SERVICE BULLETIN

COLLINS RADIO COMPANY

KWM SERVICE BULLETIN NO. 5

SUBJECT: TO IMPROVE TRANSMIT-RECEIVE EXCITER TUNING COINCIDENCE

Figure 1. Schematic Diagram, After Modification

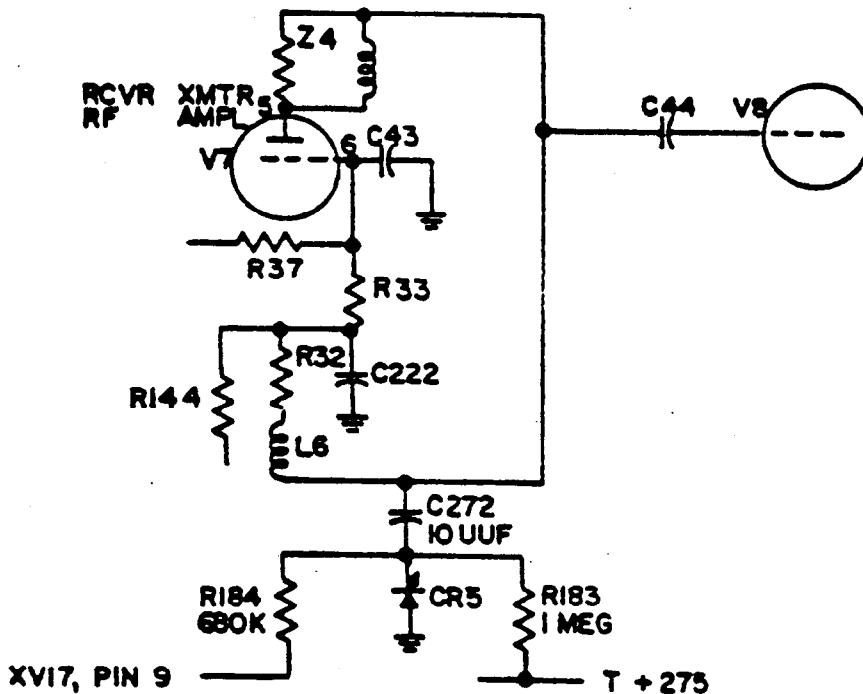
As the PA driver tube V8 is switched from transmit (conducting) to receive (nonconducting), tube capacitance changes approximately 4 uuf. This change is reflected in the plate circuit of r-f amplifier tube V7 and results in noncoincidence of transmit-receive exciter tuning on the high frequency bands.

Using the effect of capacitance change proportional to back bias voltage applied to a silicon capacitor, it is possible to add 4 uuf of capacitance to the plate circuit when the driver is in receive (nonconducting) function.

Section A: Removal of B+ from the Screen Grid of Tube V8 and Application of Bias to Control Grid of V8, When in Receive Function.

3. Turn unit bottom side up, with front panel toward operator.
4. Disconnect 22K-ohm 2-watt resistor R105 from junction of 100-ohm, 1/2-watt resistor R104 and 1000-uuf feedthrough capacitor C5 in PA grid compartment shield and reconnect to 1000-uuf feedthrough capacitor C82 in PA shield.
5. Remove bus wire located between tie points "D" and "G" on parts mounting turret E80.
6. From tie point "D" on this same parts mounting turret, transfer choke L11 to the adjacent clockwise tie point "E".
7. Proceed with Section B.

1. Connect new 10-uuf capacitor C272 (912-2753-00) from terminal "I" at the chassis end of parts mounting turret E80 to point "D" on the same mounting turret. Do not solder "D" connection.

2. Connect new 680K-ohm resistor R184 (745-0851-00) from tube socket XV17, pin 9 to tie point "D" on parts mounting turret E80. Do not solder "D" connection.

3. Observe polarity of silicon capacitor CR5 (922-6002-00). Connect anode (end marked with manufacturers' trade mark) to the ground shield of tube socket XV7. Connect cathode (color coded end) to tie point "D" on parts mounting turret E80. Do not solder "D" connection.

4. Connect new 1 meg-ohm resistor R183 (745-0857-00) from tie point "B" on parts mounting turret E70 to tie point "D" on parts mounting turret E80.
5. Solder connections to tie point "D".
